TENNESSEE VALLEY AUTHORITY

May 3, 1985

As a result of discussions between TVA and NRC Region II representatives and of TVA's ongoing review of the Watts Bar unit 1 technical specifications, we have enclosed several additional proposed technical specification changes. Please note that corresponding changes to the Final Safety Analysis Report (FSAR) are also included as appropriate. These changes will be reflected in the next amendment to the FSAR (Amendment 56).

ENCLOSURE

TABLE 3.8-1 (Continued)

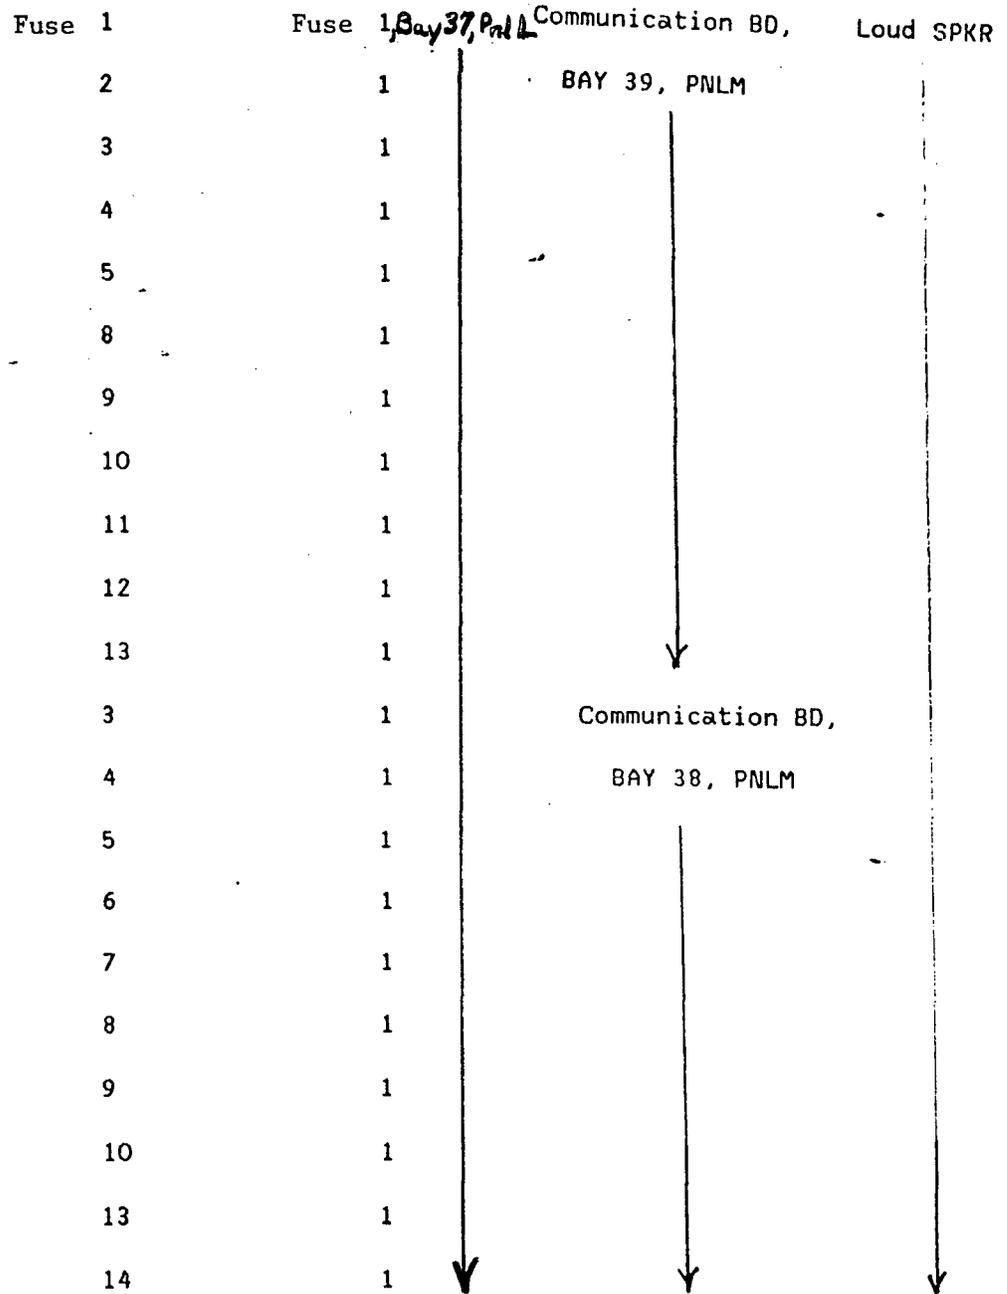
As a result of the review of Table 3.8-1 by the Watts Bar plant quality assurance staff, four changes to TVA's proposed Table 3.8-1 were identified. Attached are marked-up pages showing the following changes:

- (1) Entry on Page 3/4 8-37 which was indicated to be deleted should stay.
- (2) Insert J should have 12A(-) changed to 12A(+) on the primary device number.
- (3) Typographic error corrected on Insert X
- (4) Description of backup devices in Insert SS revised to uniquely identify the fuse.

This entry  
should  
stay in
